UNITED STATES PATENT AND TRADEMARK OFFICE

APPLICATION NO.	FILING DATE	FIRST NAMED INVENTOR	ATTORNEY DOCKET NO.	CONFIRMATION NO.
09/680,277	10/06/2000	Je Hong Kim	2658-0242P	8486

Office Action Summary

DETAILED ACTION

FIG. 4

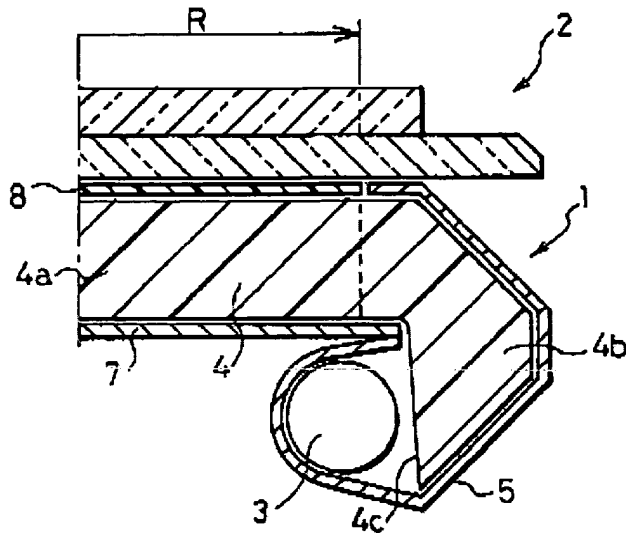
Oyama teaches in Figure 4 a light unit comprising a light-guide plate, 4a, and a reflector, 5, having a sectional view of spiral shape that efficiently guides the light

(Applicant's high focus) from the light source to the light guide plate (col. 6, lines 13-24).

Oyama is evidence that ordinary workers in the art of liquid crystals would find the reason, suggestion, or motivation to add efficient reflection (high focus) to reduce bright lines in the display near the light source (col. 13, lines 33-52, especially lines 42-48).

Therefore, it would have been obvious to one having ordinary skill in the art of liquid crystals at the time the invention was made to modify the light input of APA with the efficient reflection (high focus) of Oyama.

FIG.14(b)

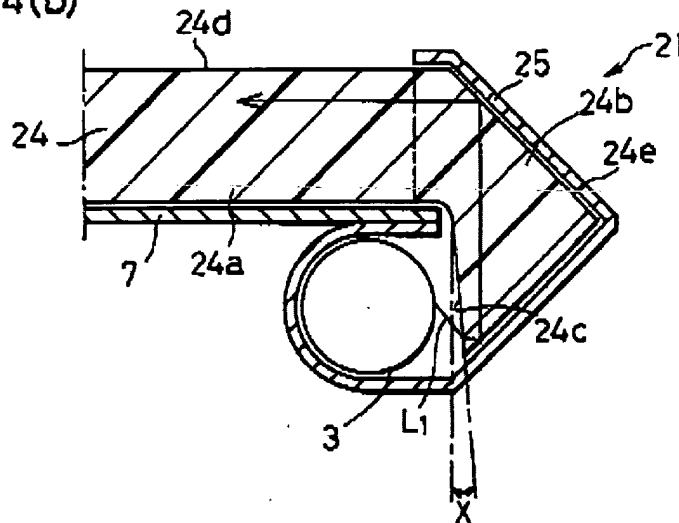
As to claim 5, Oyama teaches in Figure 14(b) a light unit wherein the reflective plate, 25, is curved to obtain a desired vertical incident angle of the light beam progressing to the light-guide plate to reduce bright lines in the display near the light source (col. 13, lines 33-52, especially lines 42-48).

Oyama is evidence that ordinary workers in the art of liquid crystals would find the reason, suggestion, or motivation to use a light unit wherein the reflective plate is curved to obtain a desired vertical incident angle of the light beam progressing to the light-guide plate to provide desired illumination characteristics.

Therefore, it would have been obvious to one having ordinary skill in the art of liquid crystals at the time the invention was made to modify the LCD of APA with the curved reflective plate of Oyama.

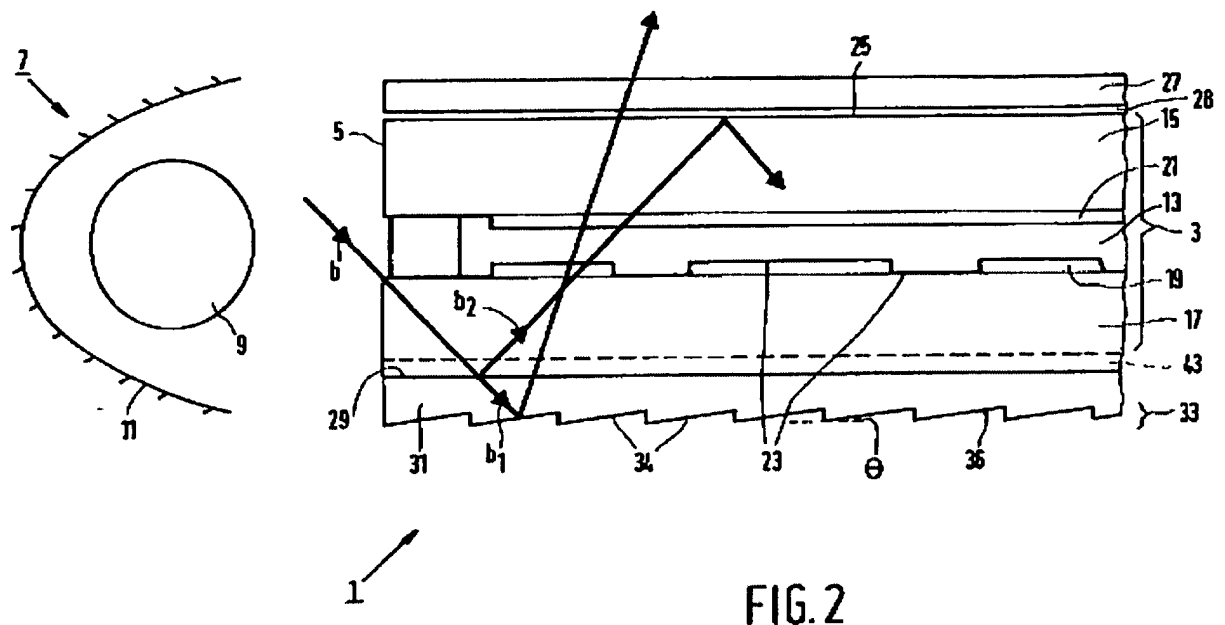
As to claim 7, Oyama teaches in Figure 14(a) a light unit wherein the lamp housing includes at least one reflective plate for cutting off the light beam progressing

directly from the lamp into the light-guide plate, the at least on reflective plate being a protrusion of the inner surface of the lamp housing.

Oyama is evidence that ordinary workers in the art of liquid crystals would find the reason, suggestion, or motivation to use a reflective plate for cutting off the light beam progressing directly from the lamp into the light-guide plate, the at least on reflective plate being a protrusion of the inner surface of the lamp housing to provide desired illumination characteristics.

Therefore, it would have been obvious to one having ordinary skill in the art of liquid crystals at the time the invention was made to modify the LCD of APA with the protruding reflective plate of Oyama.

FIG. 7

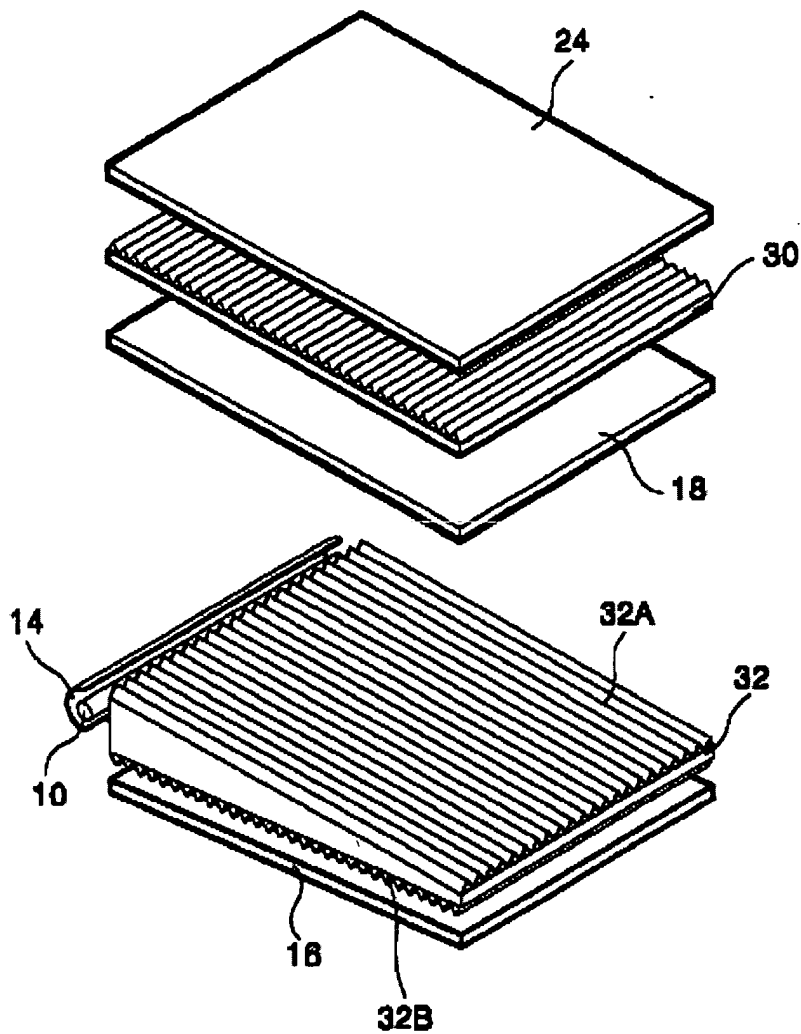
Kim teaches in Figure 7 the use of a light unit wherein the light-guide plate includes a plurality of prism patterns arranged on another surface thereof in intersection with the unit patterns.

Kim is evidence that ordinary workers in the art of liquid crystals would find the reason, suggestion, or motivation to add a plurality of prism patterns arranged on

another surface thereof in intersection with the unit patterns to enhance the utilization ratio of the light generated by the lamp (col. 6, line 58 through col. 7, line 15).

Therefore, it would have been obvious to one having ordinary skill in the art of liquid crystals at the time the invention was made to modify the LCD of APA in view of Broer with the plurality of prism patterns arranged on another (upper) surface of the light guide plate of Kim.

FIG. 1

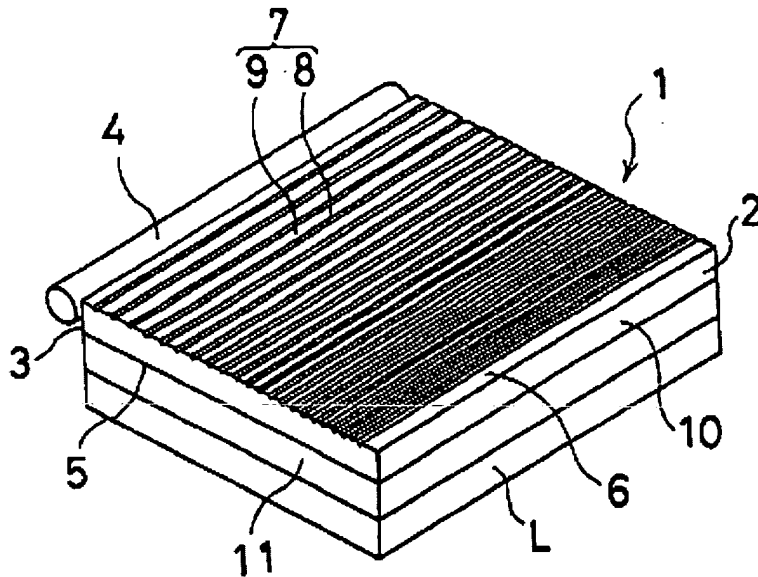
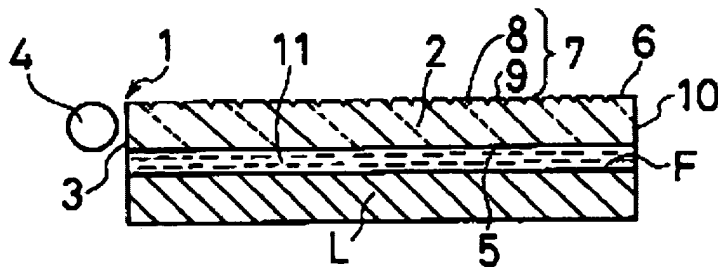
Egawa teaches in Figures 1 and 2 a light guide plate dispose on the front side of a liquid crystal panel to provide illumination without degrading contrast and without generating a moiré pattern (col. 4, lines 11-17).

Egawa is evidence that ordinary workers in the art of liquid crystals would find the reason, suggestion, or motivation to add a light guide plate disposed on the front side of a liquid crystal panel to provide illumination without degrading contrast and without generating a moiré pattern.

Therefore, it would have been obvious to one having ordinary skill in the art of liquid crystals at the time the invention was made to modify the LCD of APA in view of Oyama and Broer with the light guide plate disposed on the front side of a liquid crystal panel of Egawa.

Egawa teaches in Figures 1 and 2 a light guide plate wherein a distance between the unit patterns that gets gradually shorter as said unit patterns get farther away from the incident side of the light-guide plate so that the brightness becomes nearly uniform at any position in the transparent substrate (light guide) without being influenced by the distances from the light source lamp (col. 12, lines 34-50).

Egawa is evidence that ordinary workers in the art of liquid crystals would find the reason, suggestion, or motivation to add a distance between unit patterns that gets gradually shorter as said unit patterns get farther away from the incident side of the light-guide plate so that the brightness becomes nearly uniform at any position in the light guide without being influenced by the distances from the light source lamp.
